CONSTRUCTION BULLETIN

CHIPOTLE MEXICAN GRILL

2

Project: *Rincon GA, 5224*

C-111

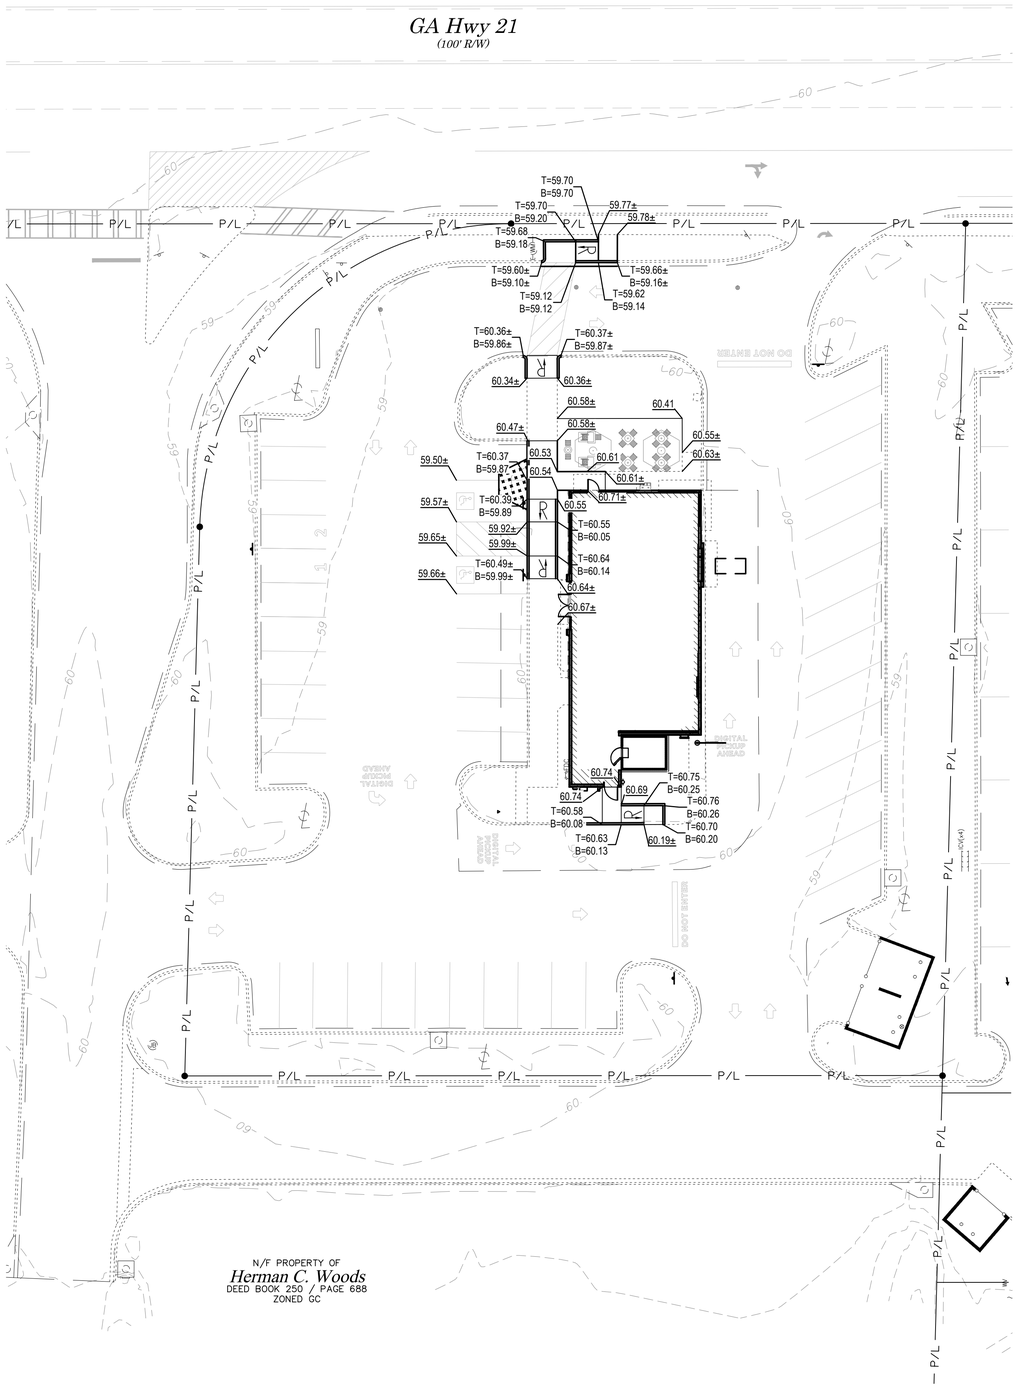
Description:
C-111: Keynote 15 has been been udpated.

1 A110 **ARCHITECTURAL FLOOR PLAN**
1/4" = 1'-0"

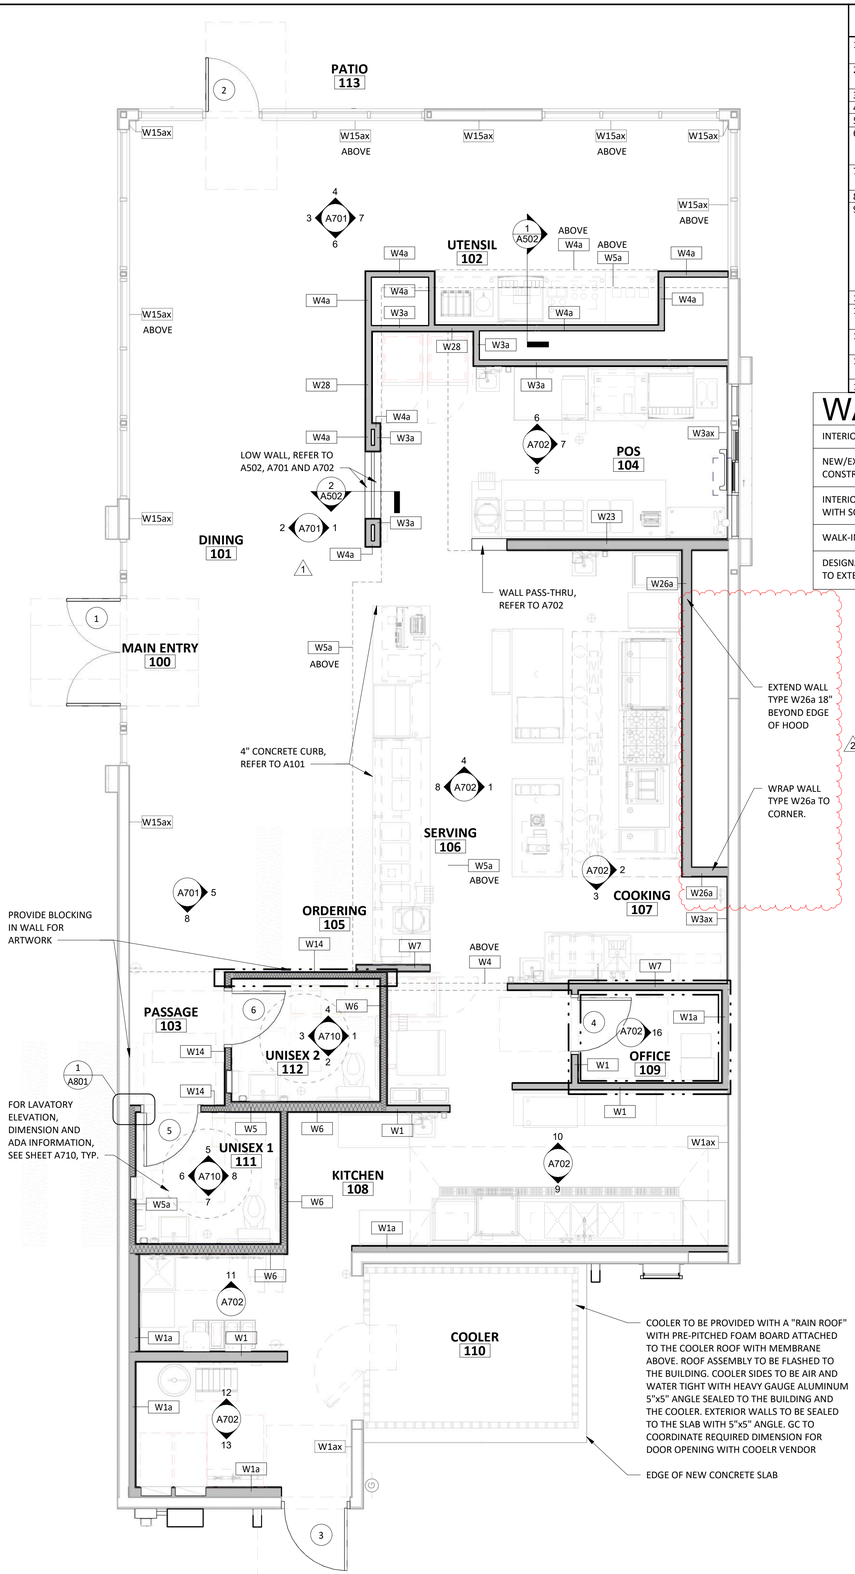
1/A110: Wall type around corner from kitchen hood updated to W26a to provide adequate fire protection.

1 / A130 **FURNITURE, FIXTURE & EQUIPMENT PLAN**
1/4" = 1'-0"

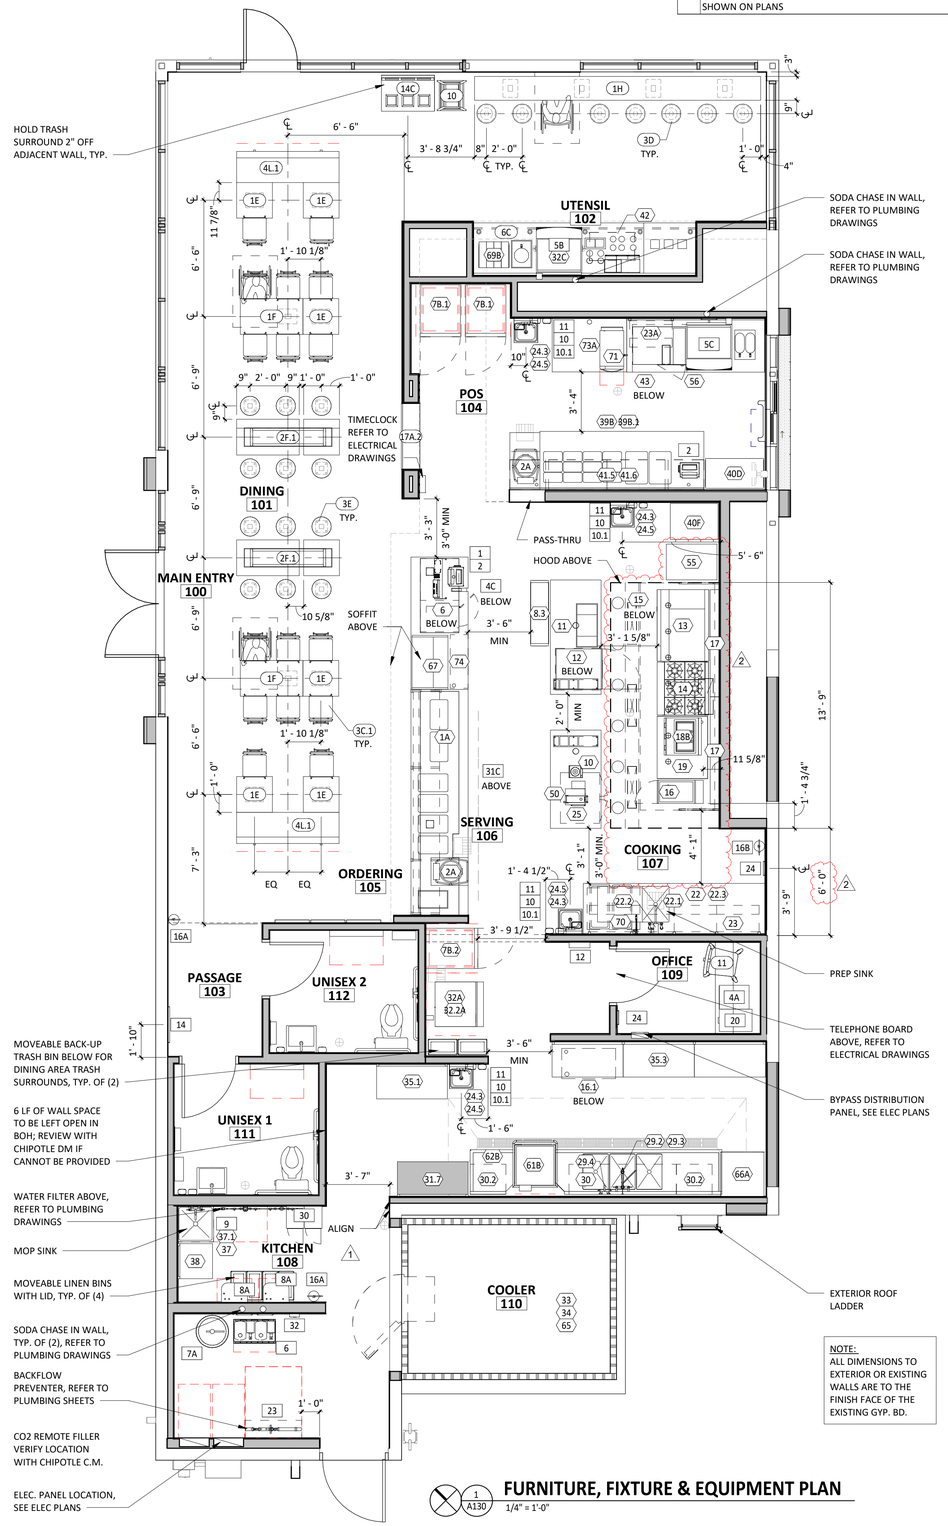
1/A130, 2/A702: Cooking equipment under the hood/adjacent to the hood was rearranged slightly to accommodate this shift.

1 A201 **REFLECTED CEILING PLAN**

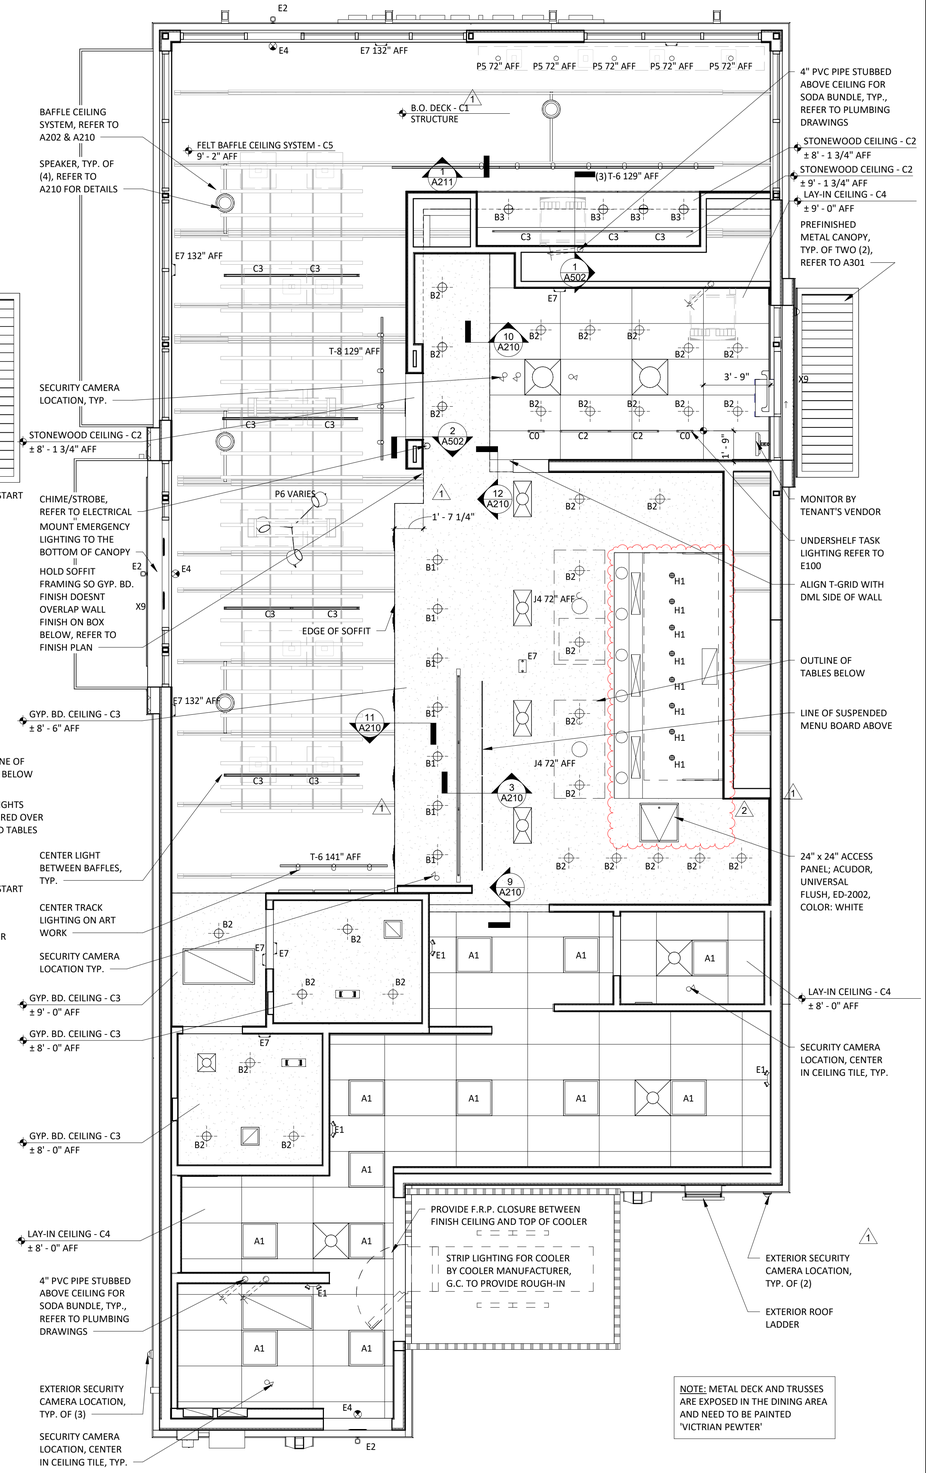
1&2/A201: Ceiling access panel shifted with kitchen hood

1 S110 **ROOF FRAMING PLAN**
1/4" = 1'-0"

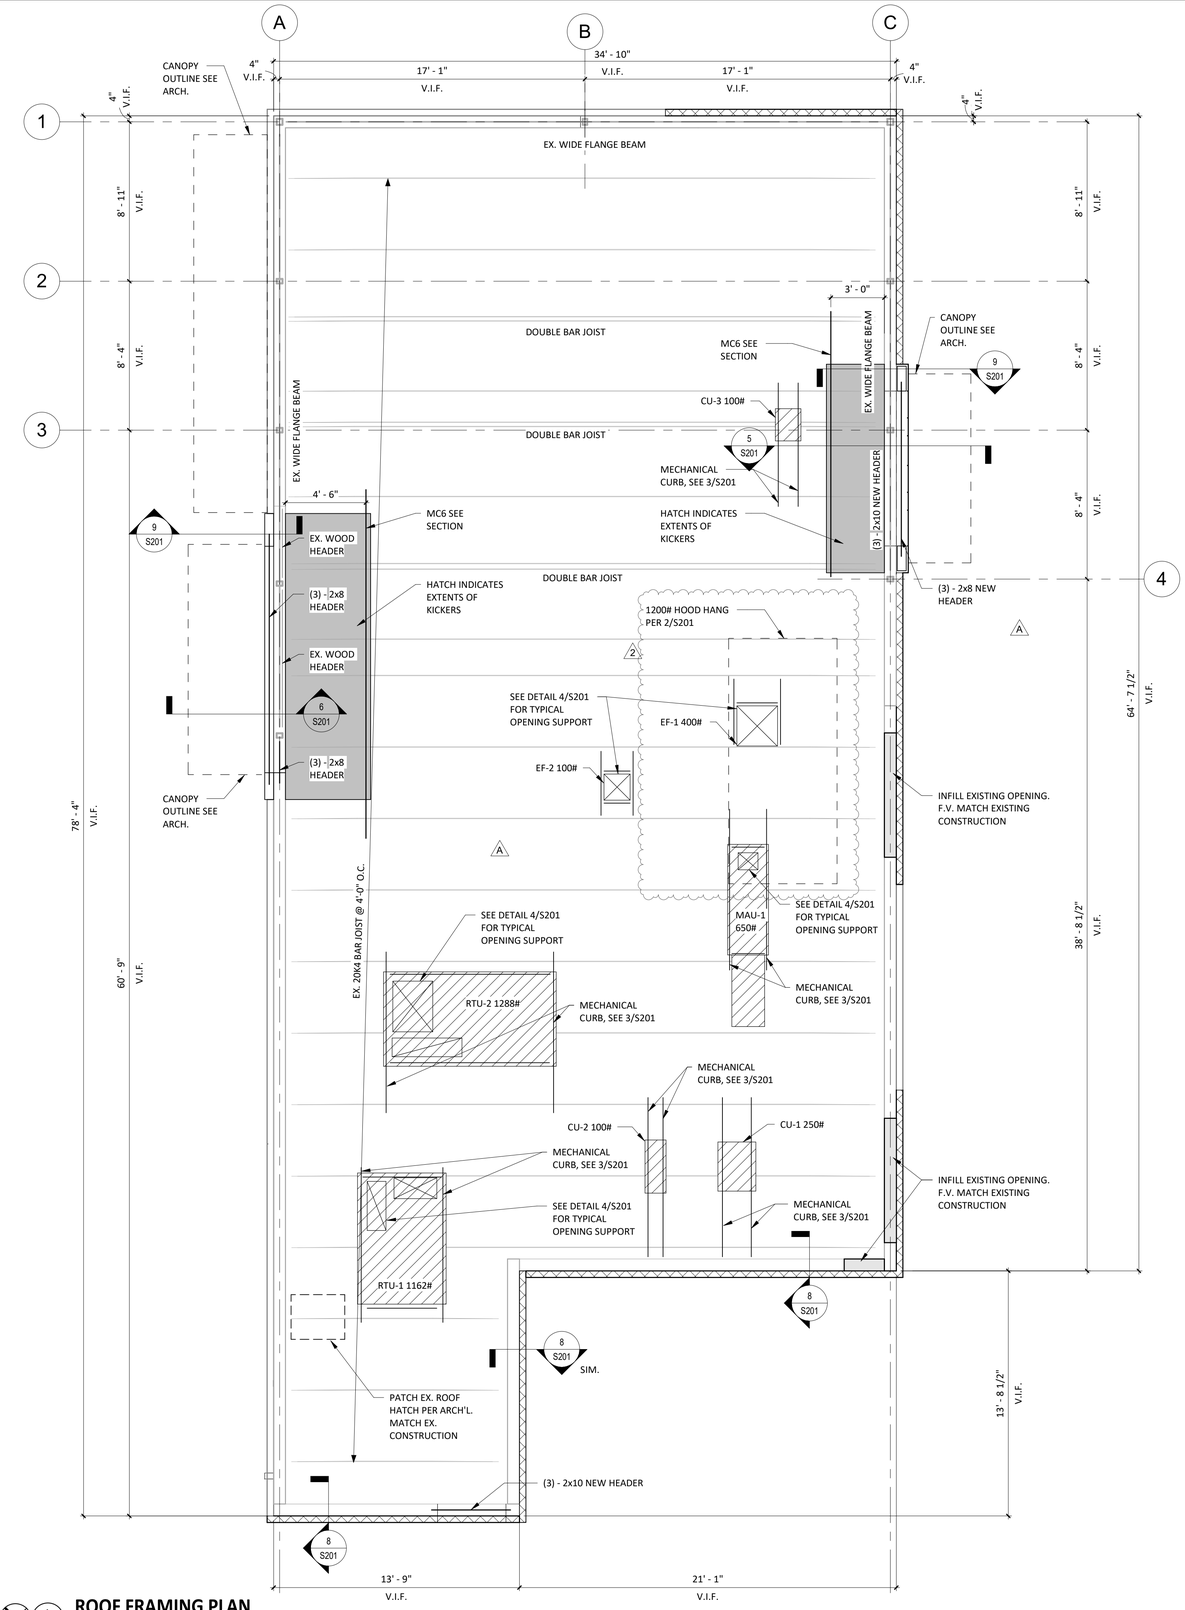
1/S110: Shifted hood hang to align with architectural.

1 M100 **HVAC FLOOR PLAN**
1/4" = 1'-0"

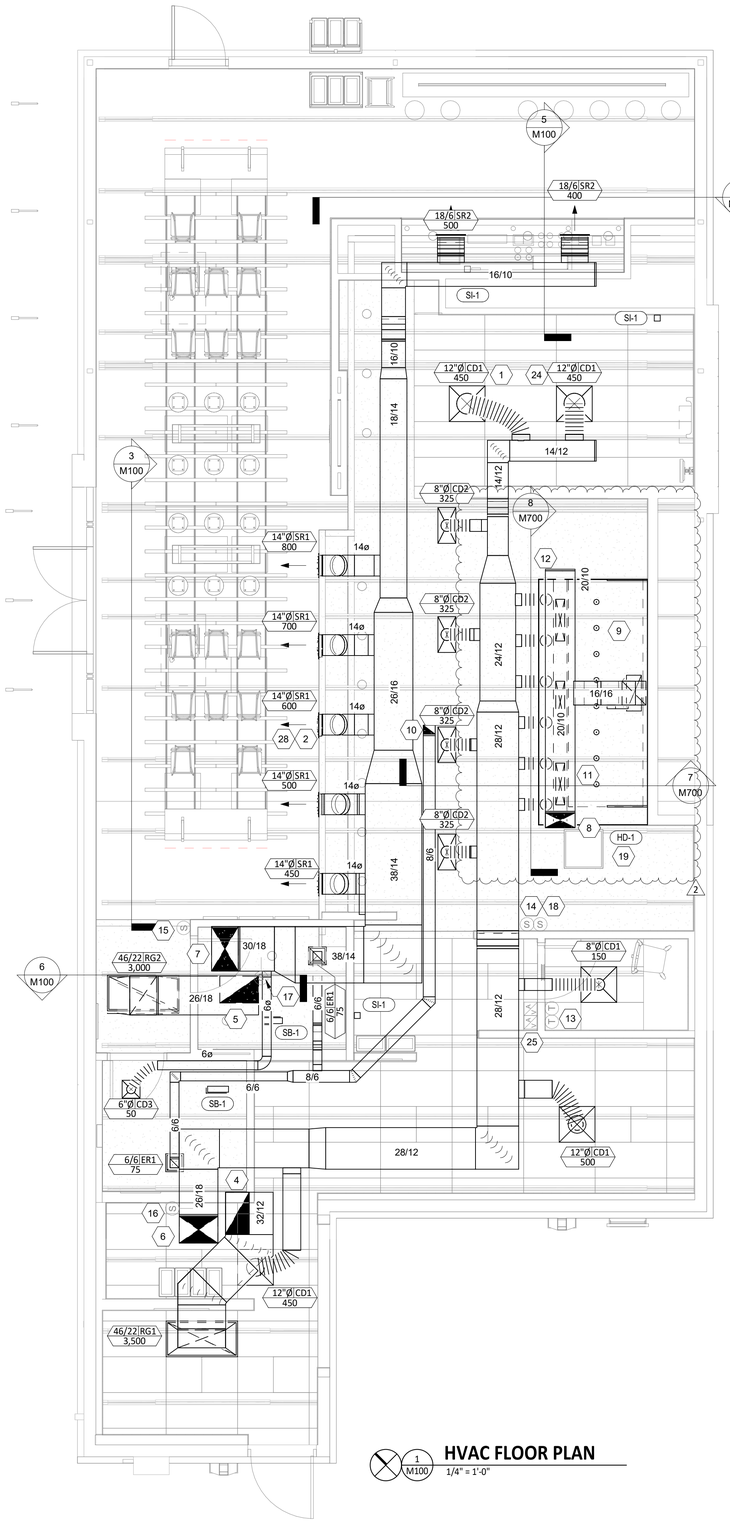
1&2/M100, 8/M700: Hood and associated ductwork / rooftop equipment (EF-1, MAU-1) shifted.

PLUMBING SUPPLY PLAN
1/P100 1/4" = 1'-0"

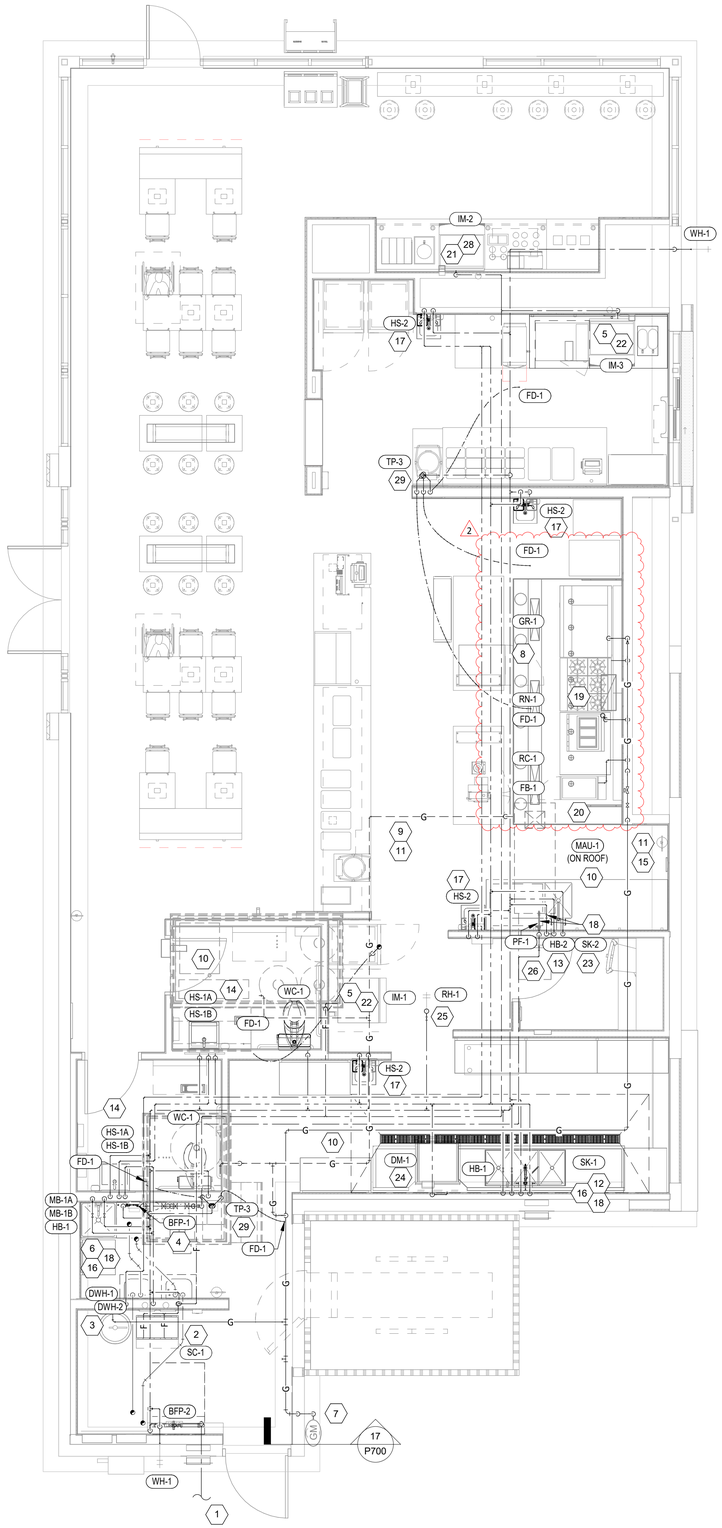
1/P100: Gas stub outs serving cooking equipment shifted with the kitchen hood.

POWER FLOOR PLAN (1/E110) 1/4" = 1'-0"

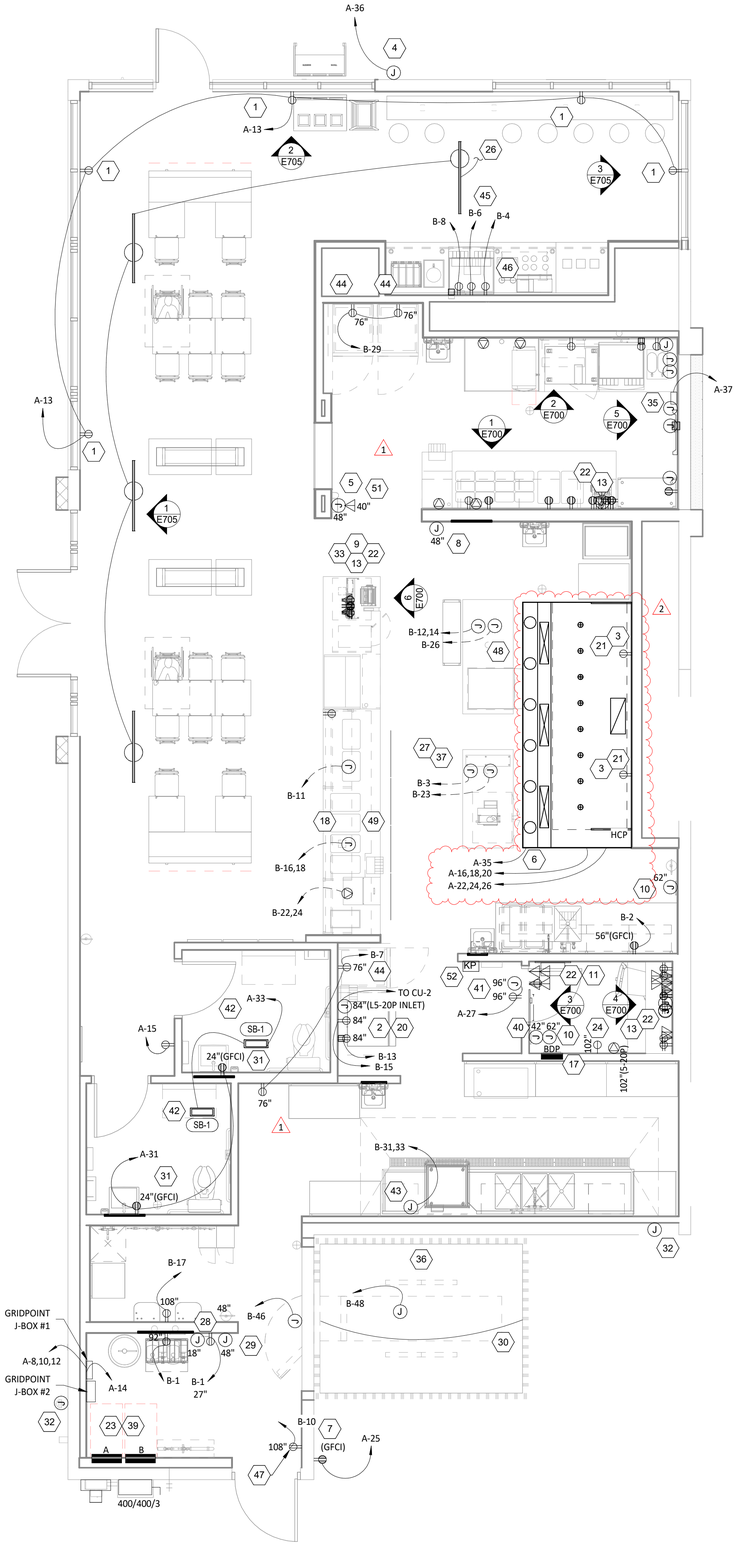
1/E110: Location of hood receptacles have been updated.
